Amirichimeh *et al.*
Appl. No. 10/813,363

Appl. No. 10/813,363
Amendment dated: Nov. 7, 2007
Reply to Office Action of Aug. 9, 2007
Sheet 1 of 1
ANNOTATED SHEET

FIG. 6C

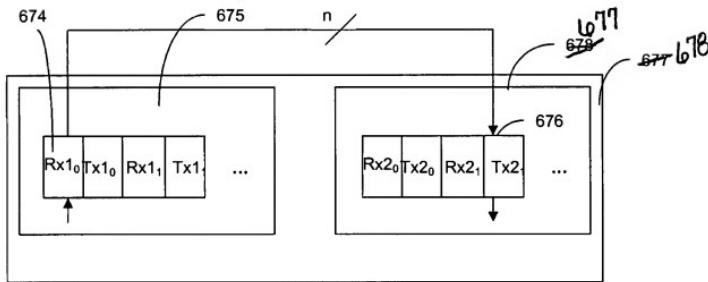
In the specification, the title is sought to be amended to correct a typographical error. In the drawings, Figure 6C is sought to be amended to switch reference numbers 677 and 678 to correspond with the discussion found in paragraph [0058] of the specification as originally filed. Annotated and replacement drawing sheets showing Figure 6C are submitted herewith. These changes introduce no new matter, and their entry is respectfully requested.

The current Office Action states on page 2, section 2, that the drawings are objected to “because the arrow indicating common substrate 678 in Figure 6C and disclosed in paragraph [0058] is pointing at the core rather than at the substrate.” In order to address this objection, Figure 6C is sought to be amended to switch reference numbers 677 and 678 such that reference number 677 points to the core and reference number 678 points to the substrate as discussed in paragraph [0058] of the originally filed specification. These changes add no new matter. Accordingly, Applicants respectfully request that the objection to the drawings be reconsidered and withdrawn.
